Subject: AP1000 COL Standard Technical Report Submittal of APP-GW-GLN-019, Revision 1
(TR 103)

1. APP-GW-GLN-019, Revision 1, "Fluid System Changes," Technical Report Number 103

WESTINGHOUSE ELECTRIC COMPANY
AP1000 Licensing Design Change Document

Title: Fluid System Changes

Figure 6.2.2-1 (Sheet 2 of 2)
Passive Containment Cooling System
Piping and Instrumentation Diagram
(REF) PCS 002

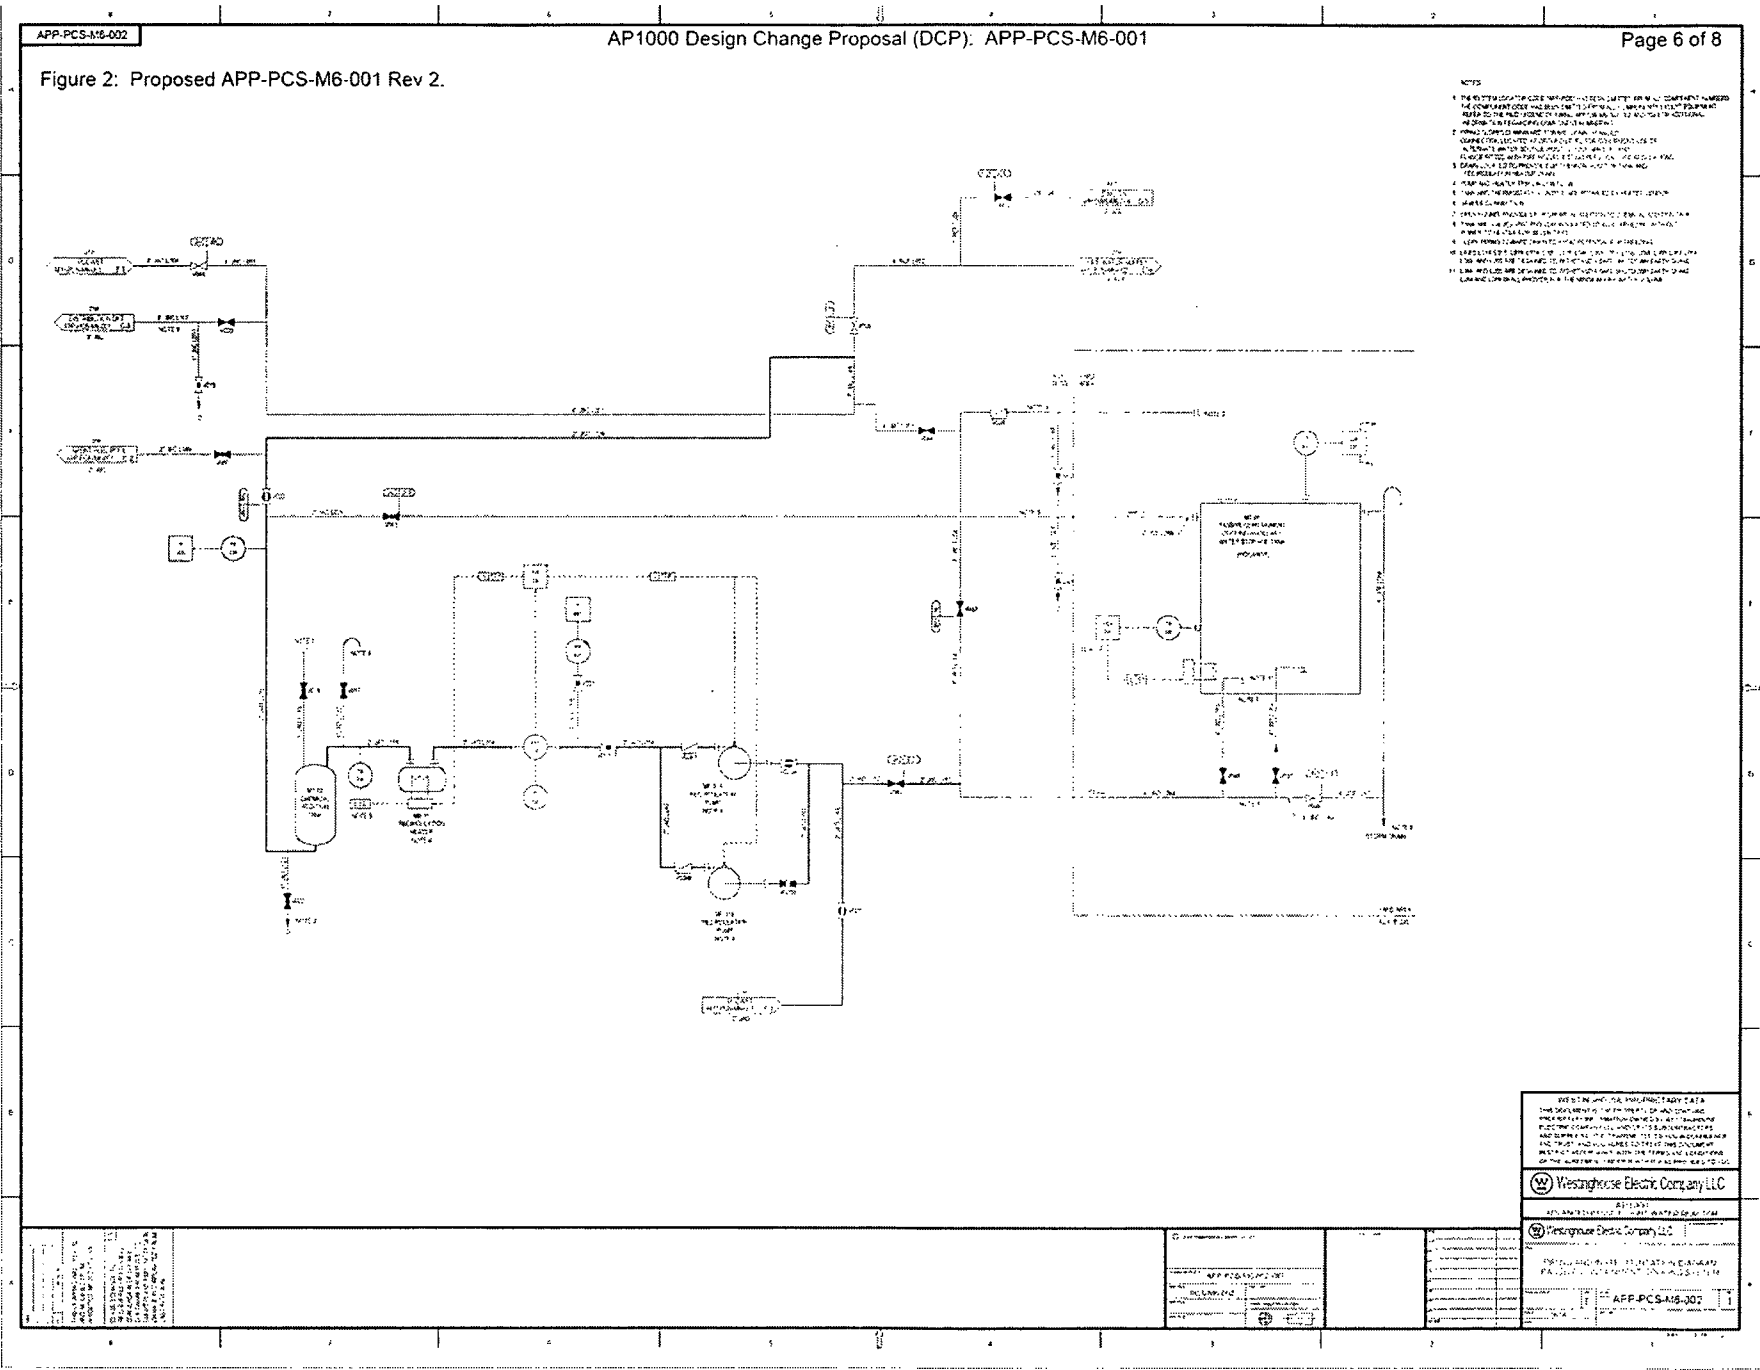
The Passive Containment Cooling System (PCS) P&ID has been updated to reflect the current PCS design. The recirculation heater has been moved upstream of the chemical addition to accommodate a horizontal heater as opposed to a vertical heater. Also, the piping connection to the heater is now flanged instead of welded. The P&ID has also been modified to show the tank's chemical addition line as an independent connection. The tank has separate connections for the chemical additive and water. The P&ID also showed a connection between lines L029 and L051 when no such connection exists in AP1000. Line L029 actually connects to line L048. Finally, the connecting tees between lines L080 and L064, L046 and L057, and L051

Section III contains a markup of changes to DCD Figure 6.2.2-1.

Figure 6.4-2
Piping and Instrumentation Diagram Main Control Room
Emergency Habitability System

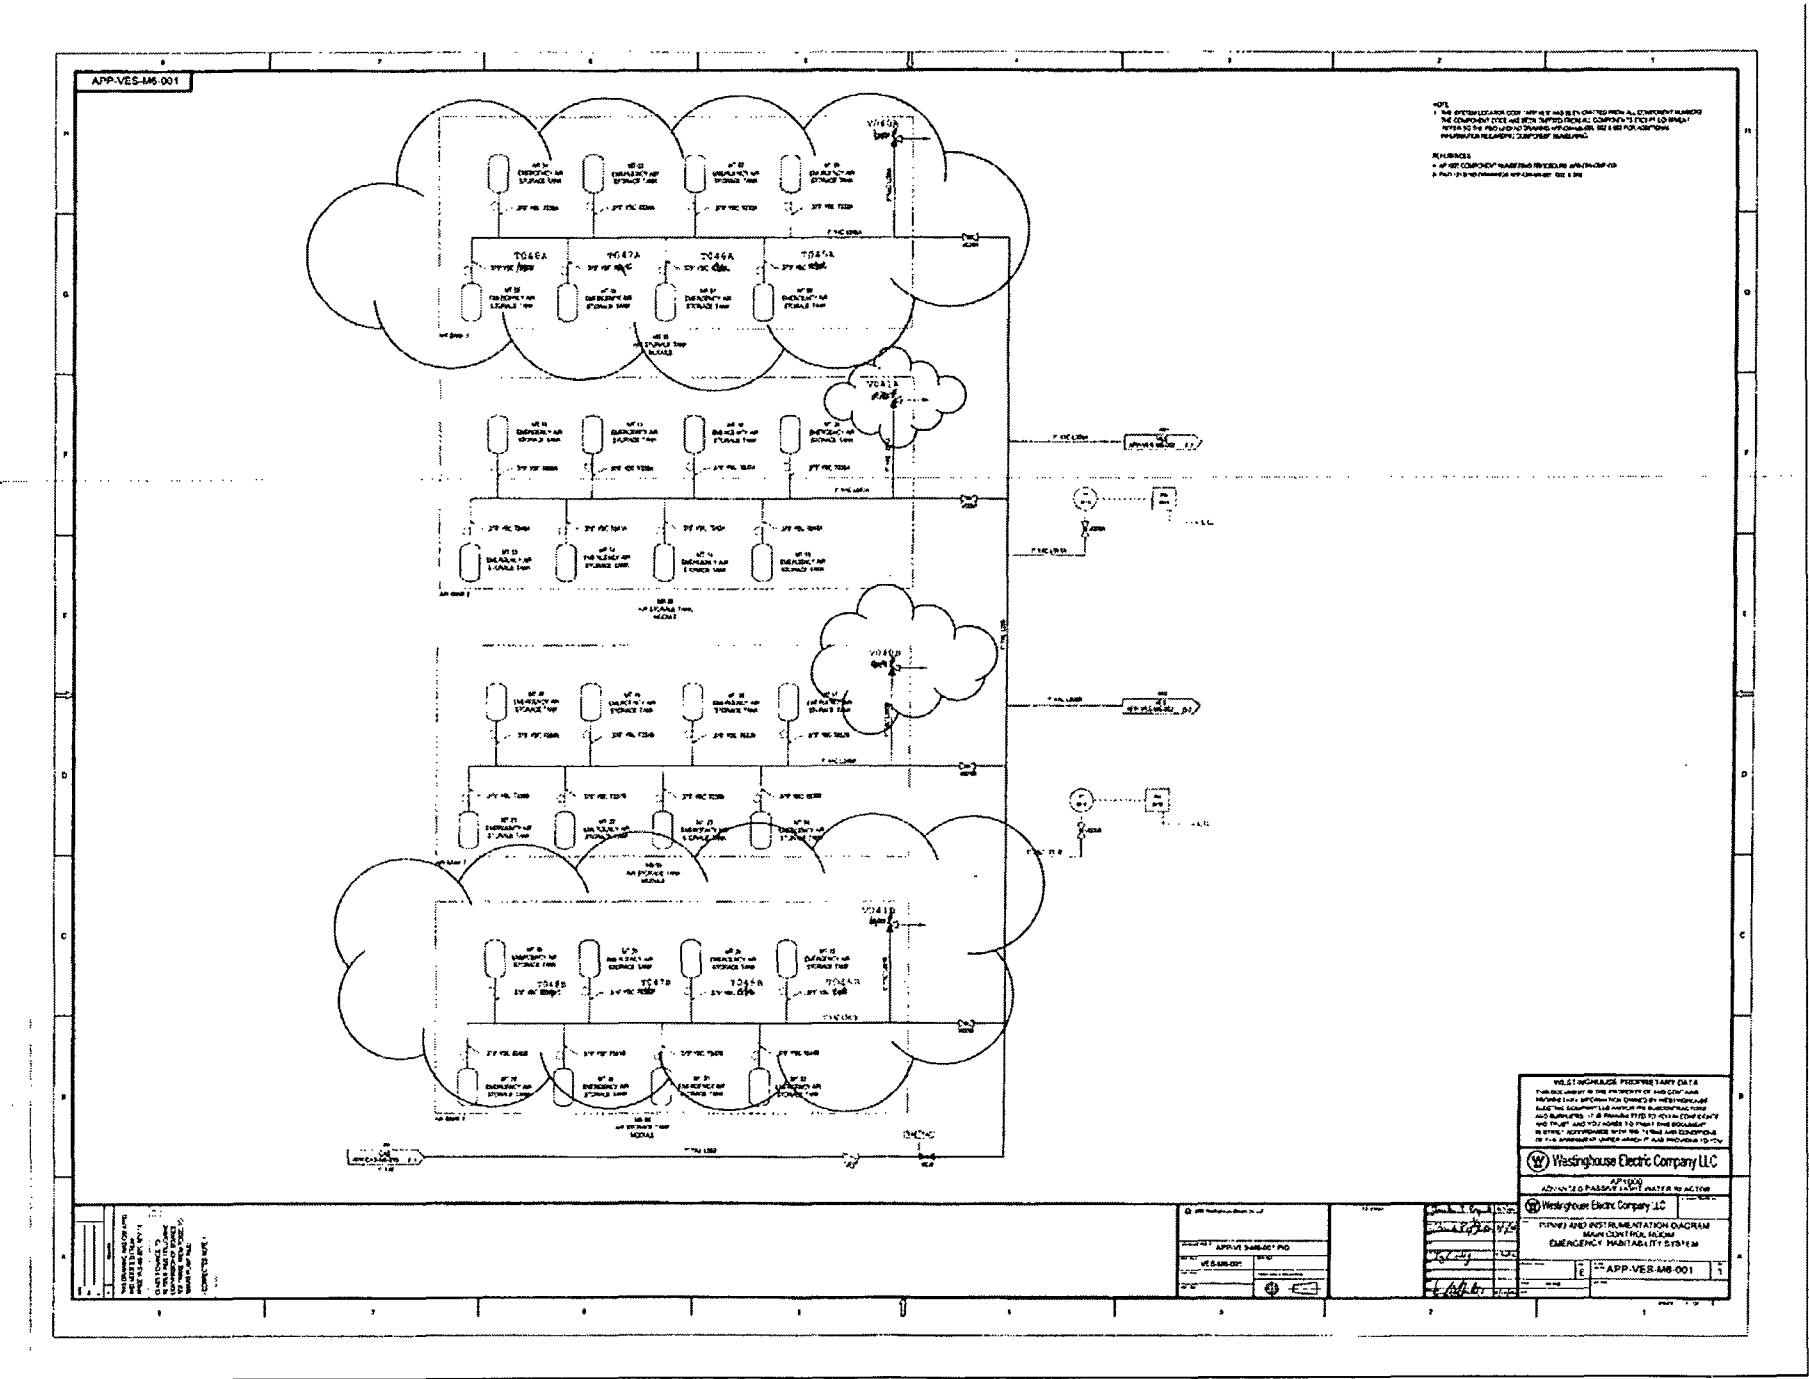
AP1000 Control Room Emergency Habitability System (VES) Piping and Instrumentation Diagrams (P&IDs) have been updated to correct line and valve number duplications and inconsistencies present in the current version of the diagrams. The description of the AP1000 VES in the Tier 2 section of the AP1000 DCD includes Figure 6.4-2.. The markup is shown in Section III of this document.

Figure 9.1.6 (Sheet 1 of 2)
SFS Pump Common Suction Pipe (L050) and RCS Engineering Flow Diagram

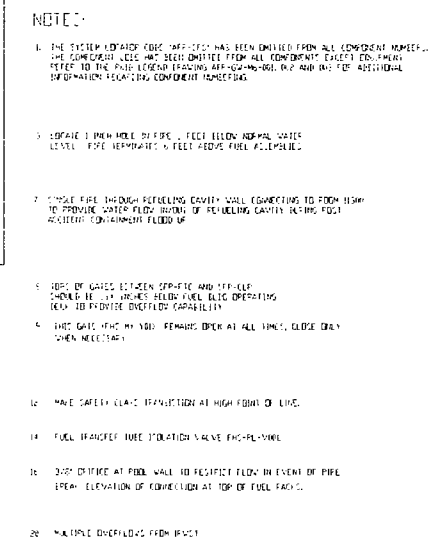
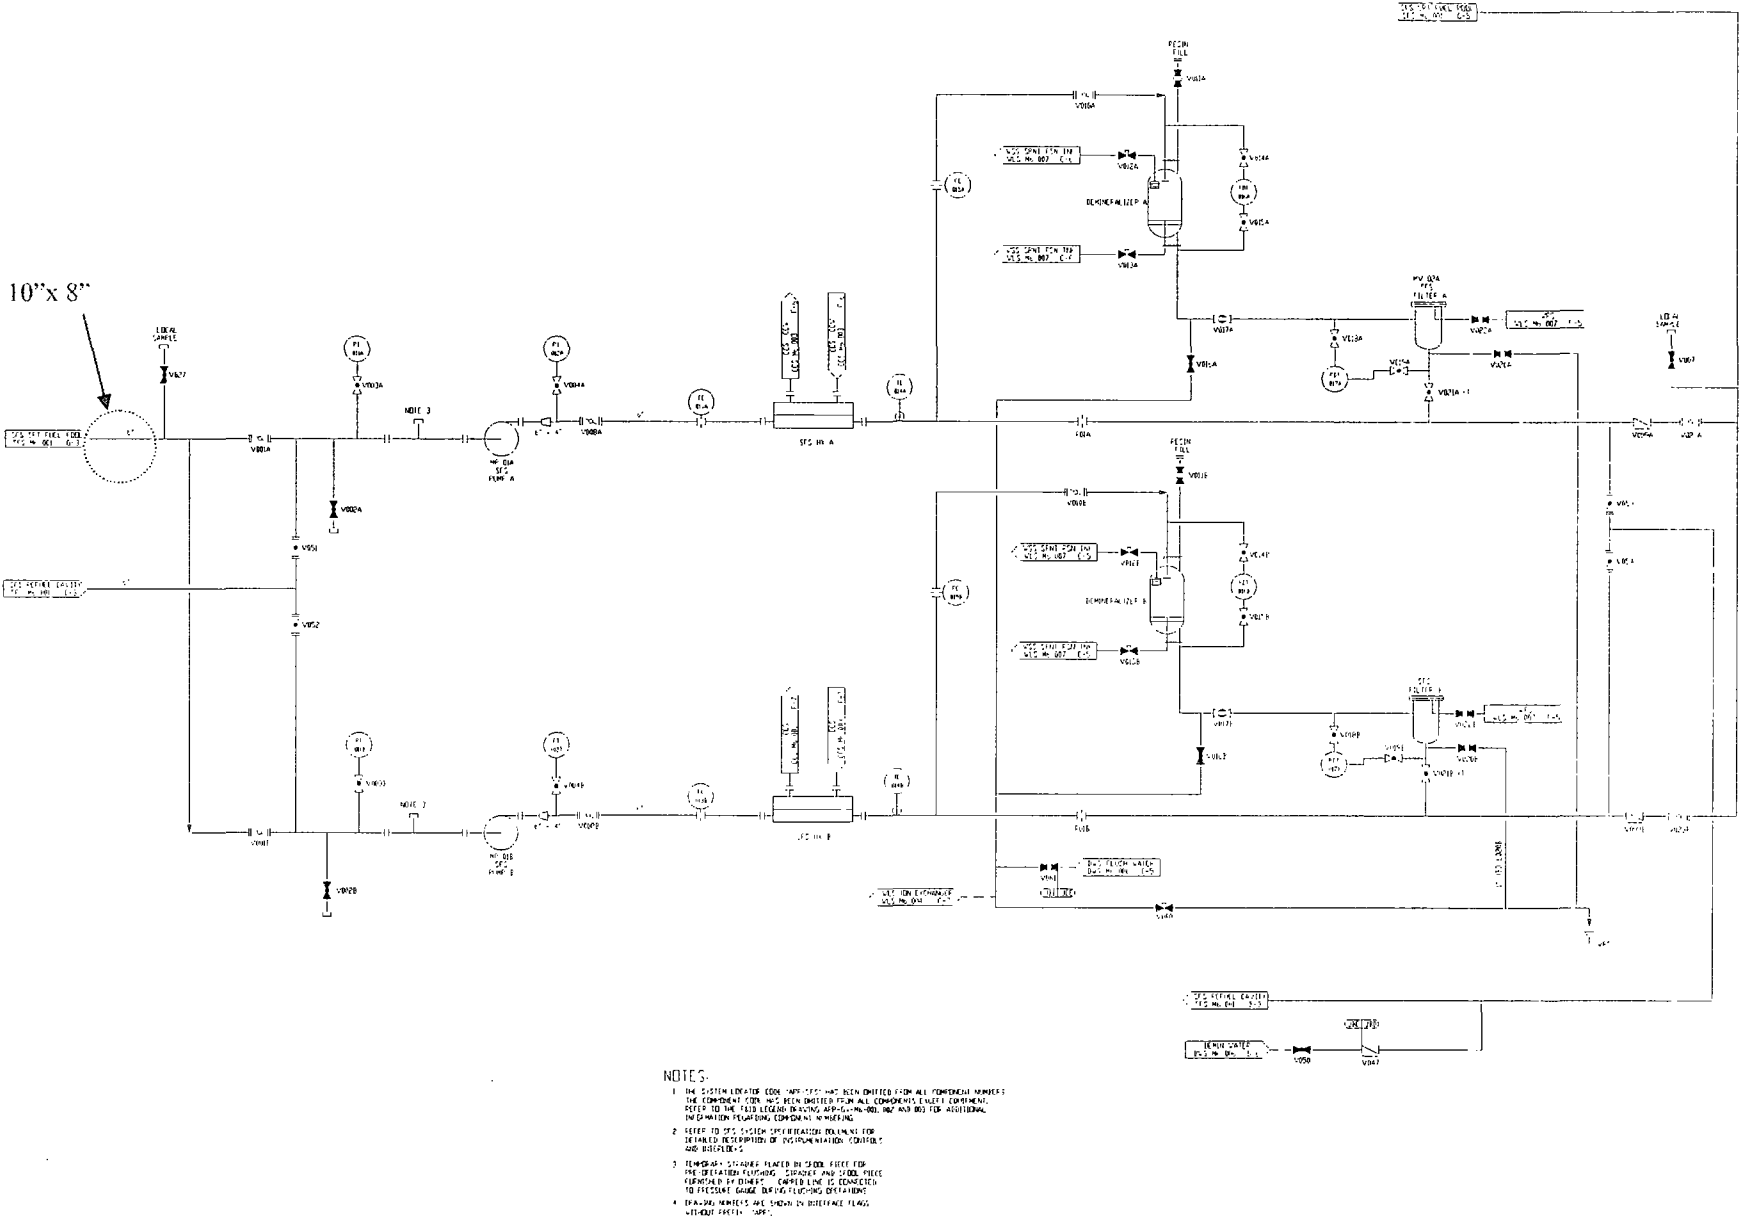
This change increases the SFS common suction pipe from 6 inch, Sch 40 to 10 inch, Sch 40 from the SFP to the penetration at the SFS pump room. The line is then reduced from 10 inch, Sch 40 pipe to 8 inch, Sch 40 pipe from the pump room penetration to line L001A. The remainder of the SFS suction piping will remain 6 inch, Sch 40.

This change increases the size of line the SFS pump common discharge line from 6-inch, Sch 40 to 8-inch, Sch 40. This change, combined with the reduced ΔP in the pump suction line, decreases the pump required head.

Figure 9.2.1-1
Service Water Systems
Piping and Instrumentation Diagram
(REF) SWS 001

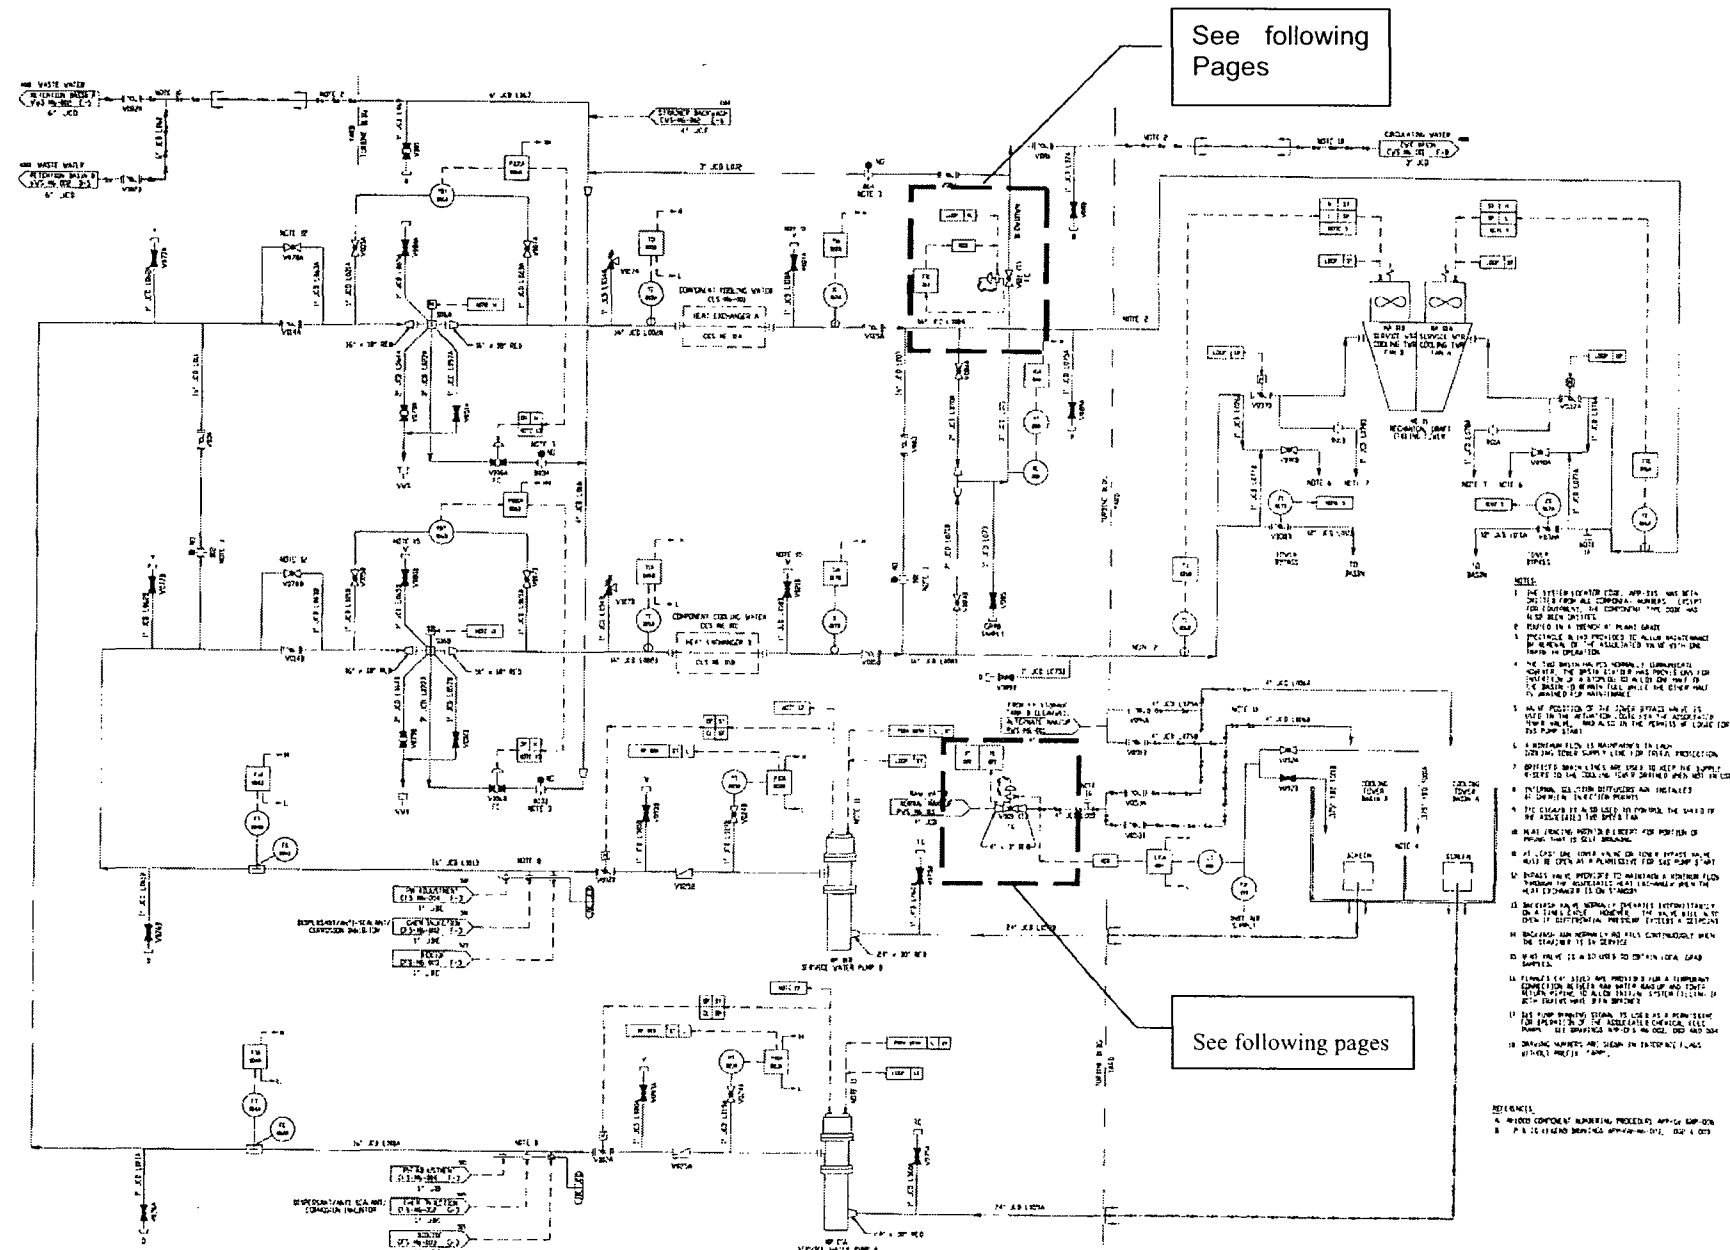
To provide the necessary design flexibility, the integral instrumentation is replaced with standard in-line instruments within the identified figures of the DCD or removed, and references to valves with internal instrumentation be removed from the DCD text. This replacement does not change the functional or design of any valves or instruments.

The diagrams in question are Figure 9.2.1-1 (Service Water System – APP-SWS-PL-V011 and –V009) and Figure 9.2.7-1 Sheet 2 of 3 (Central Chilled Water System – APP-VWS-PL-V272A/B, and -V261A/B/C/D)
